REMARKS

Applicants' attorney, Leslie Nguyen, would like to thank Examiner Burch for the courtesies extended during the telephonic interview conducted on April 19, 2006 regarding the drawing objections raised in the Office Action mailed March 3, 2006. An Interview Summary follows, after which the objections contained in the Office Action are addressed.

Amendments to the Drawings

FIG. 1b

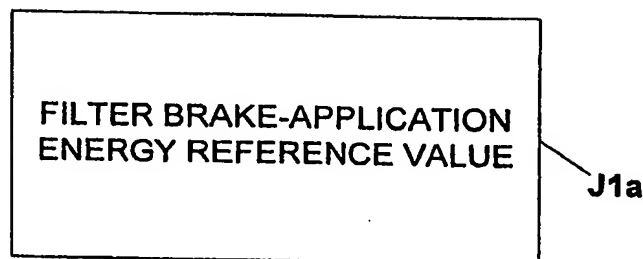
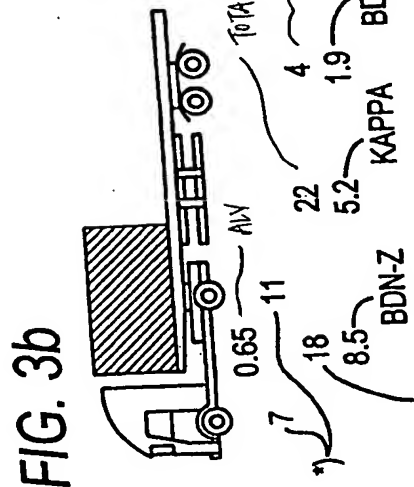
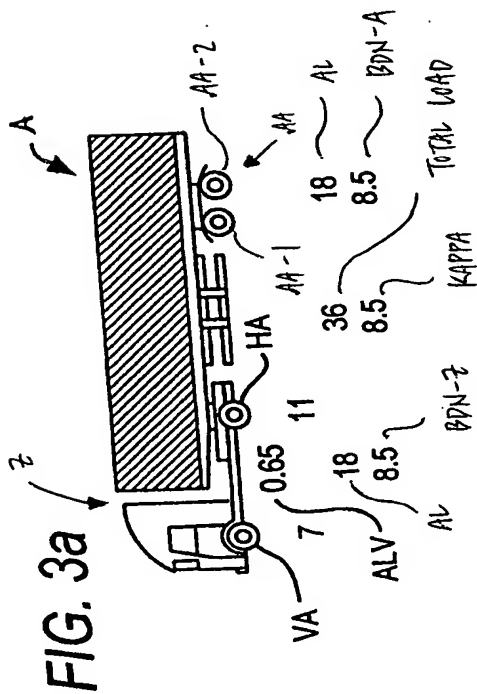
The Examiner objected to the drawing sheet containing Figs. 1b and 1c for containing the phrases “Annotated Marked-up Drawing Sheet” and “New Figure Added”. Applicants have submitted a Replacement Sheet containing Figs. 1b and 1c to replace the prior drawing sheet. This Replacement Sheet has been amended to delete the phrases “Annotated Marked-up Drawing Sheet” and “New Figure Added” and to include “New Sheet” as requested by the Examiner. It is submitted that this Replacement Sheet is in compliance with 37 CFR 1.121(d).

In addition, a Replacement Sheet containing Figs. 1b and 1c are submitted herewith. This Replacement Sheet replaces the phrases “Annotated Marked-up Drawing Sheet” and “New Figure Added” with “New Sheet” as suggested by the Examiner. No new matter has been introduced.

FIG. 4a

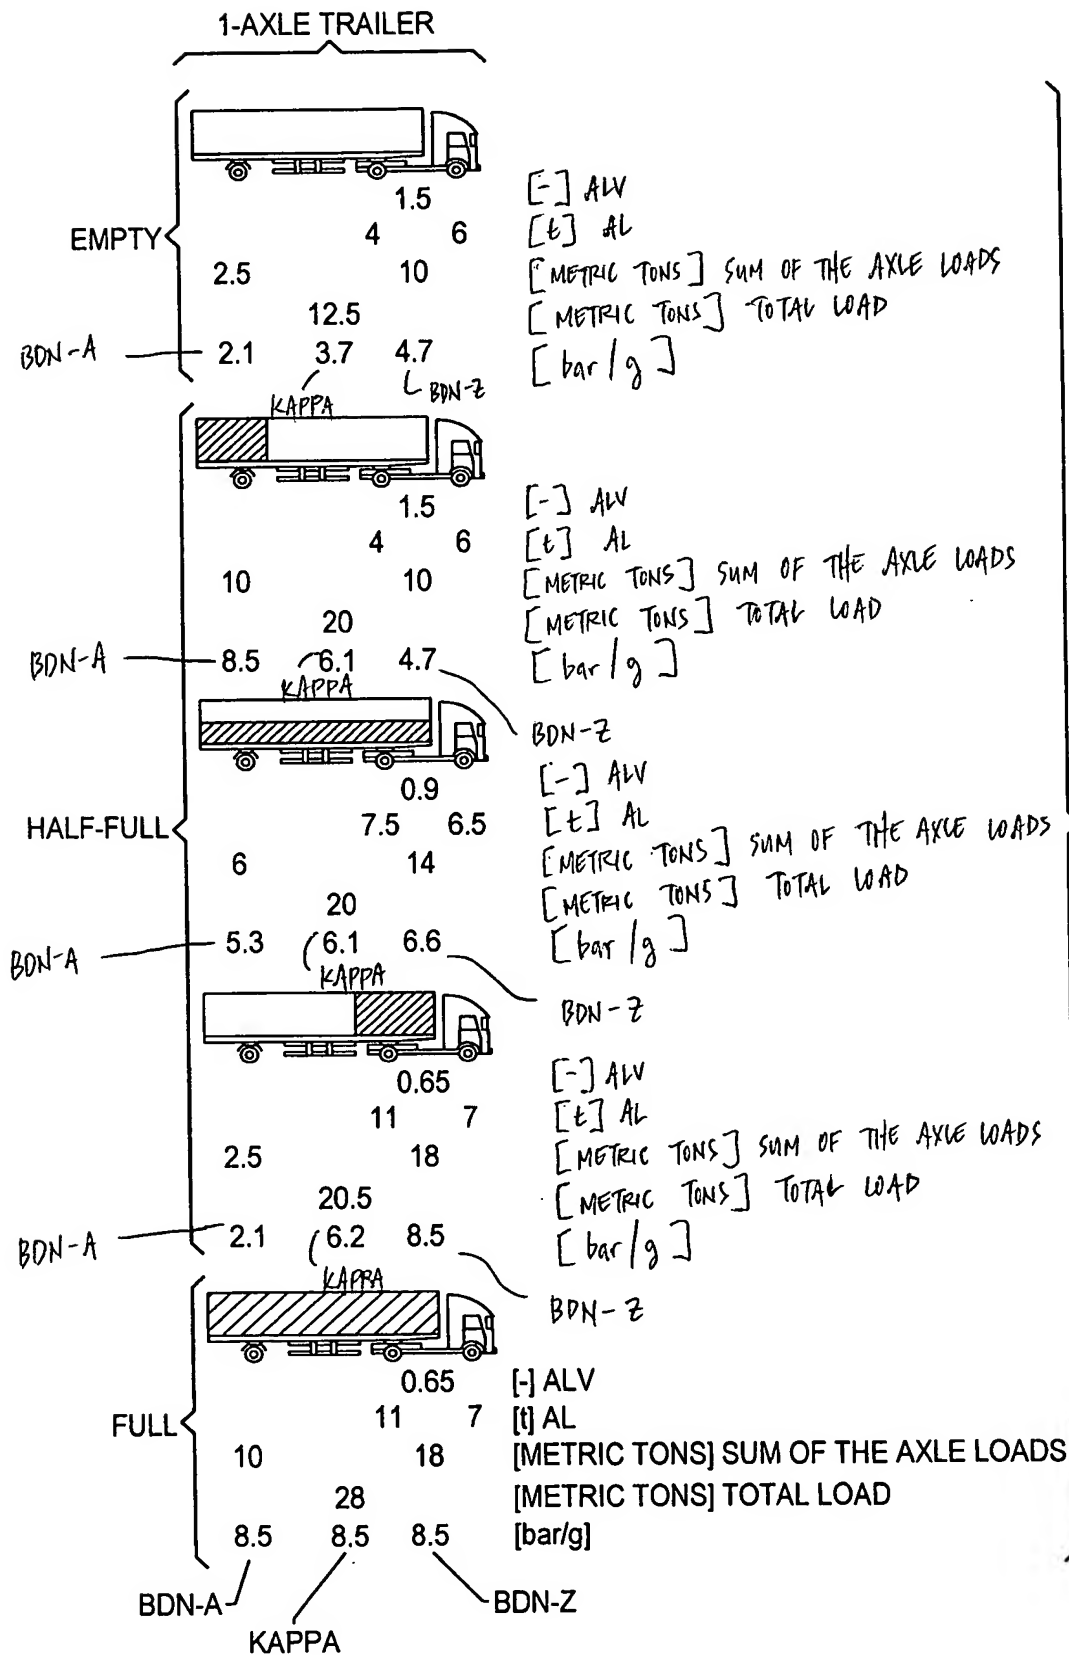
Regarding the Examiner’s objection to Figs. 3a-3e, 4a-4c, 5a-5i, 6a-6e, and 7a-7e, the Examiner suggested that each and every element in these respective figures required labeling even though Applicants’ attorney noted that each element could be understood based on the previous labeling of the figures.

Applicants have also amended Figs. 3a-3e, 4a-4c, 5a-5i, 6a-6e, and 7a-7e to label each and every element in these respective figure according to the suggestions made by the Examiner during the interview conducted on April 19, 2006. The elements of the respective figures are fully supported by the original application specification. Accordingly, no new matter has been introduced.

New Figs. 3a-3e, 4a-4c, 5a-5i, 6a-6e, and 7a-7e include additional element labels as suggested by the Examiner.

FIG. 9

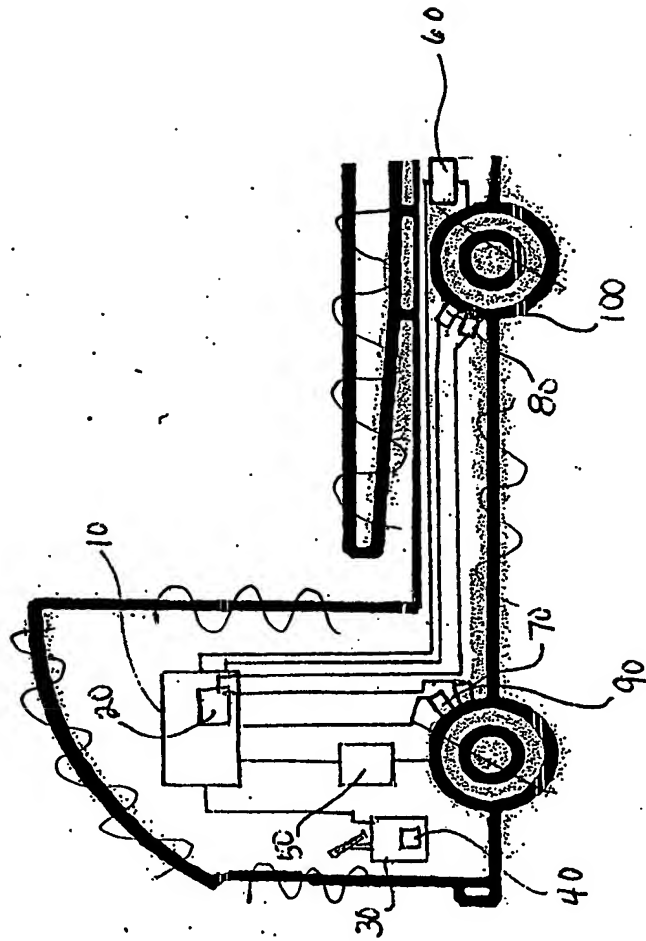
The Examiner acknowledged that Fig. 9 was initially added at the Examiner’s request. The Examiner then suggested that Fig. 9 be amended to only include a “black box” diagram of the conventional EBS (i.e. removing the “picture of the truck” from Fig. 9).

In the Office Action, the Examiner stated that Fig. 9 should be deleted because it is not supported by the original disclosure. If Applicants were to delete Fig. 9, the Examiner required that the axle load sensors recited in claim 17 and the means for determining a set deceleration value, means for measuring actual deceleration and means for comparing the set and actual deceleration values as recited in claim 26 be shown in the drawing figures.

To address the Examiner's concerns and promote the application to early allowance, as depicted in the attached Replacement Sheets, Applicants have added new Fig. 9 to the drawings which, as suggested by the Examiner during the interview conducted on April 19, 2006, is a simplified "black box" diagram of a conventional tractor-trailer vehicle combination showing an EBS and including an EBS control unit 10 (which includes the capability of effecting filtering of the brake application energy reference value) and means for determining actual deceleration 20, a brake pedal 30, including a signal transmitter for desired brake values 40, brake actuators 50, 60 for the front and rear axles, respectively, wheel speed sensors 70, 80 and

axle load sensors 90, 100. Support for the addition of new Fig. 9 resides in at least claims 17 and 28. Accordingly, no new matter has been introduced.

New Fig. 9 is a simplified schematic diagram depicting a conventional EBS for a conventional tractor-trailer vehicle combination including an EBS control unit 10 and means for determining actual deceleration 20, a brake pedal 30, including a signal transmitter for desired brake values 40, brake actuators 50, 60 for the front and rear axles, respectively, wheel speed sensors 70, 80 and axle load sensors 90, 100. No new matter has been introduced.
